**MOUNTAIN REGIONAL WATER SPECIAL SERVICE DISTRICT
PARK CITY, UTAH**

SIGNAL HILL WATER TREATMENT PLANT OPTIMIZATION

ENGINEER PROJECT NO. 203230

**ADDENDUM NO. 3
TO THE
CONTRACT DOCUMENTS**

HVAC MAIN TREATMENT BUILDING FLOOR PLAN

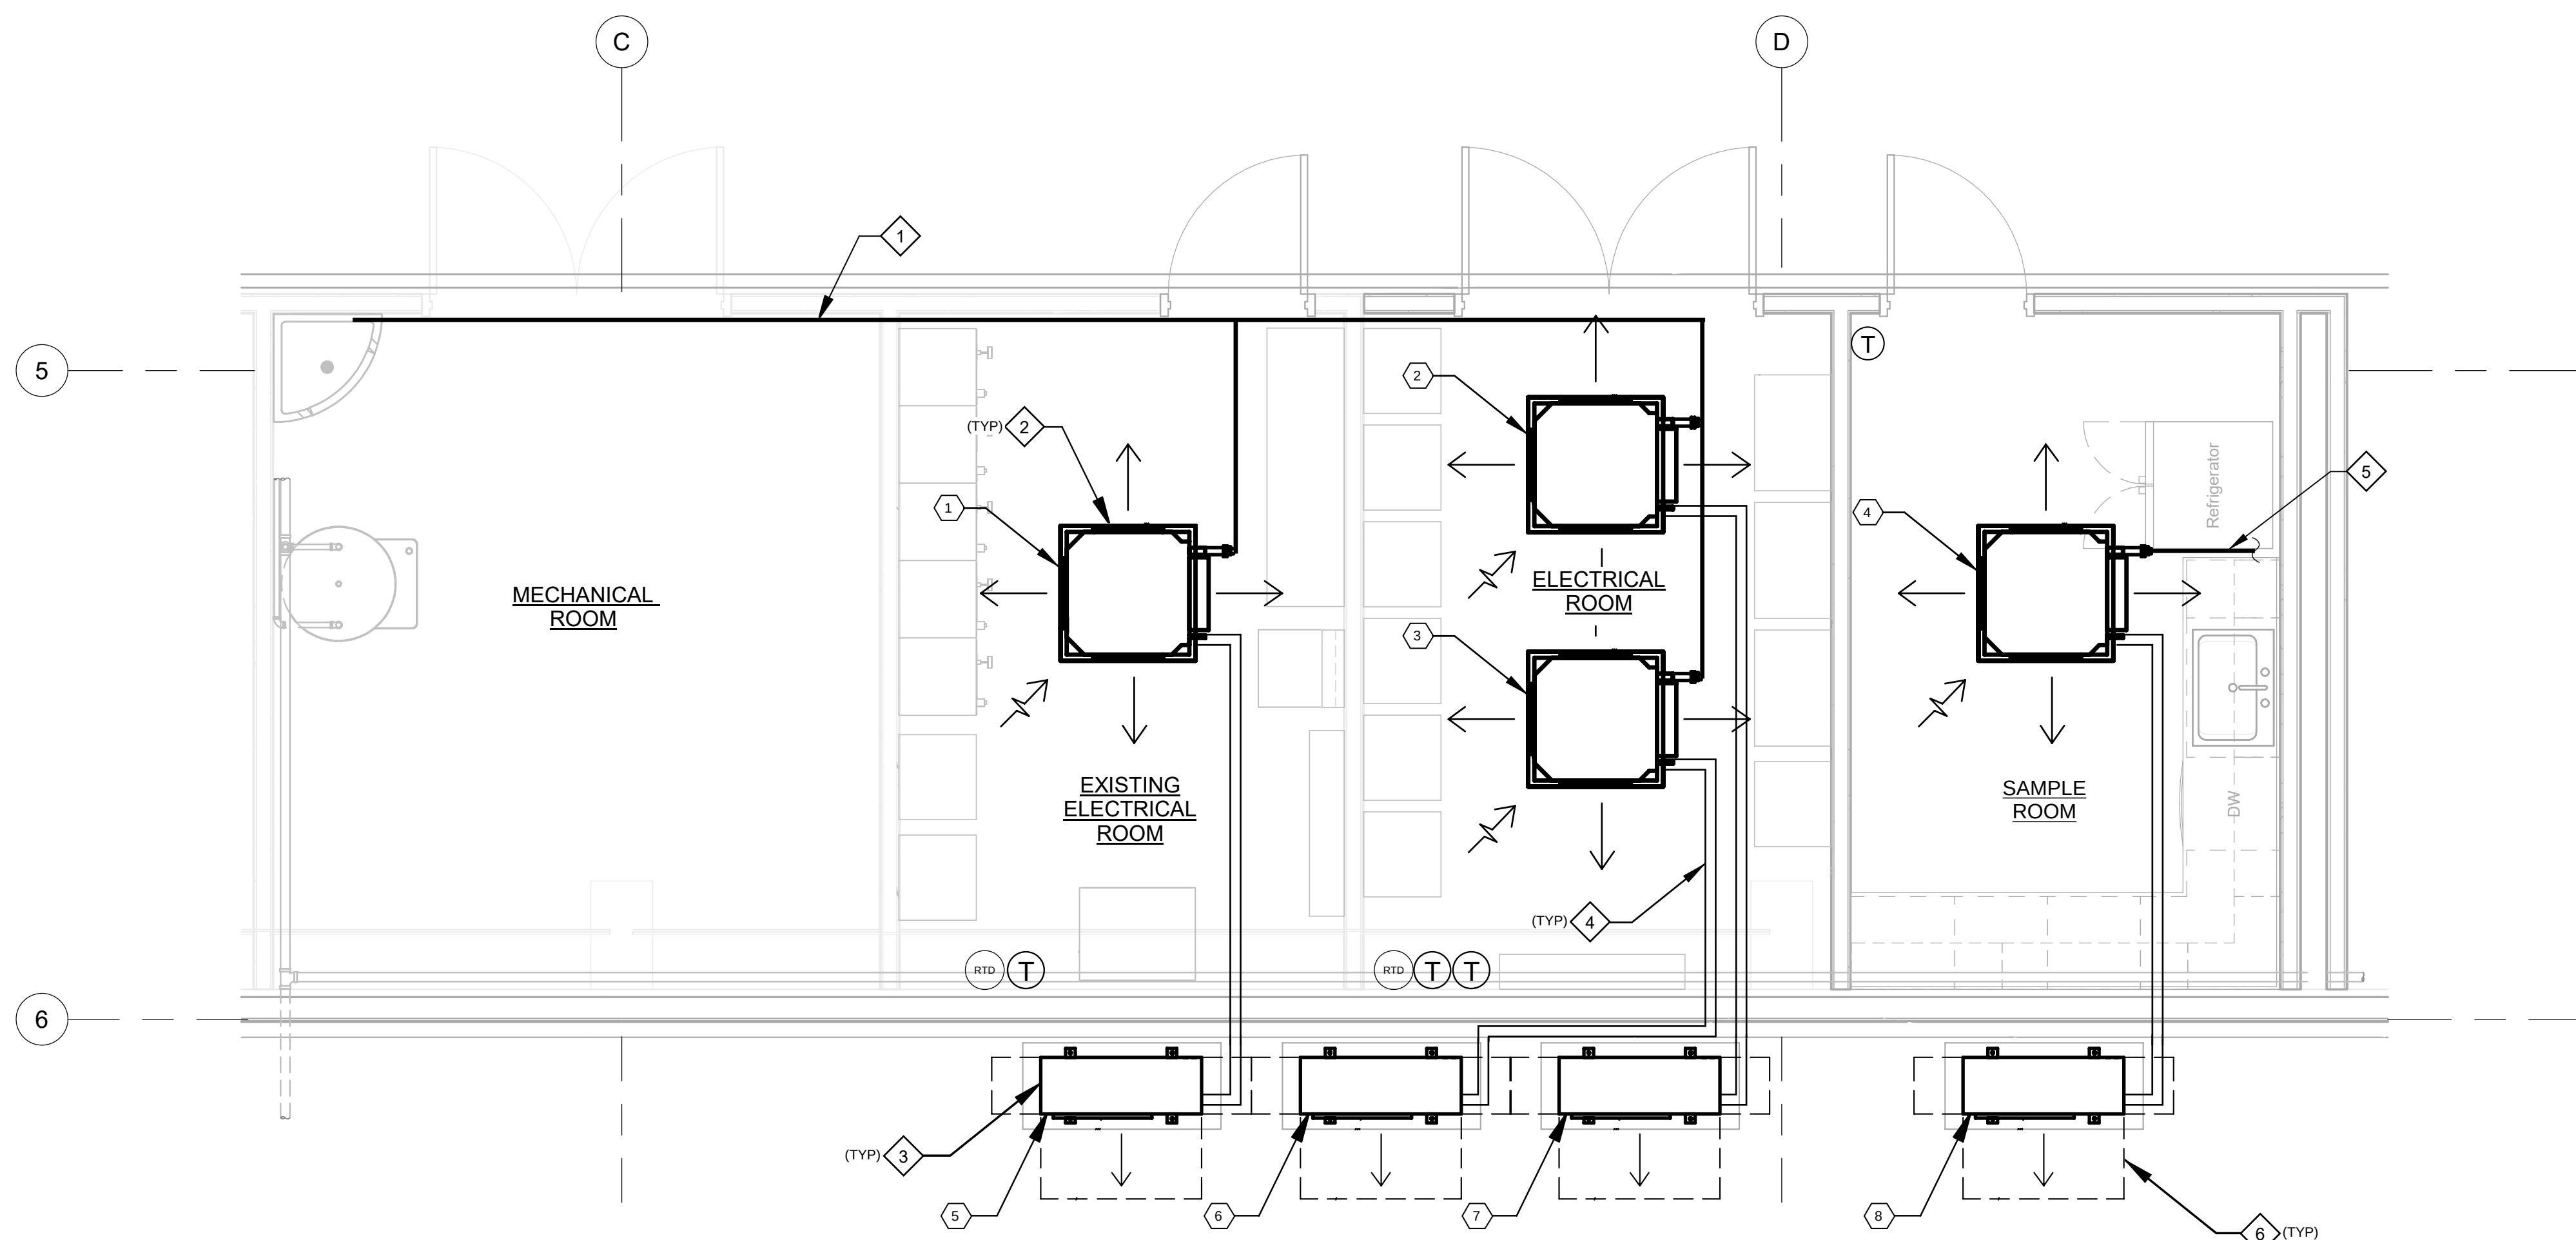
<div><div></div><div>BIDDER QUESTION LOG</div></div>	
Signal Hill Water Treatment Plant Optimization Project	
10/14/2026	
INQUIRY	FINAL RESPONSE
Fire Alarm is included in scope of work with Edwards Signaling Solutions, Honeywell, & Siemens listed as approved manufacturers, but is there an existing system that needs to be connected to?	There is an existing system. See supplemental information included in Addendum No. 3.
For 40F01 and 70F01, with a new fire suppression system being designed and installed, will the existing system be completely demolished or only adapted for the new design? For either approach, can as-built drawings be provided for the existing fire suppression system?	The existing fire system will remain in place. Per 40F01, the GAC fire protection system shall tie into the existing system. See Addendum No. 3 for supplemental information regarding the existing fire system.
Please confirm there are no HVAC drawings for the newly formed rooms in the Main Treatment Building (Rooms 102, 103).	HVAC for the interior rooms within the existing Main Treatment Building is provided via Addendum No. 3.

SR609

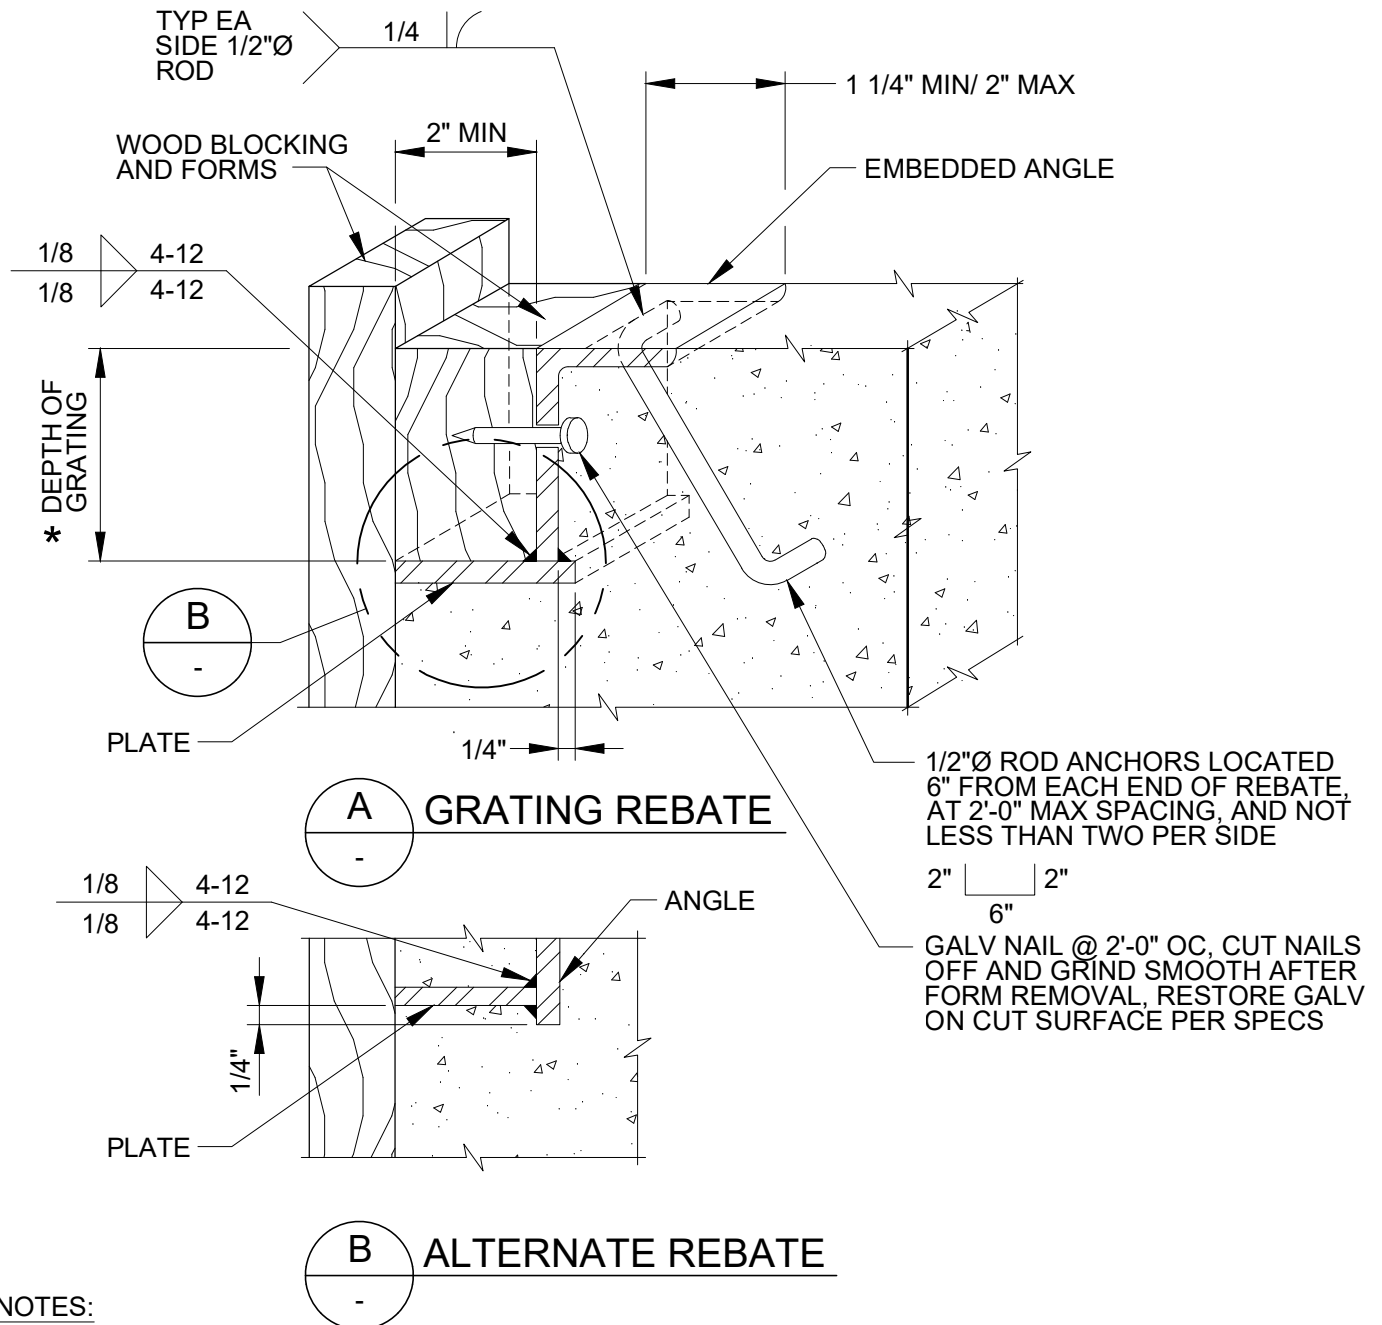
- a. ADD the attached Typical Detail SR609 to this drawing.

<p>Detail CS202 references detail SR609 which does not appear to be included in the details. Please provide.</p>	<p>See Addendum No. 3.</p>
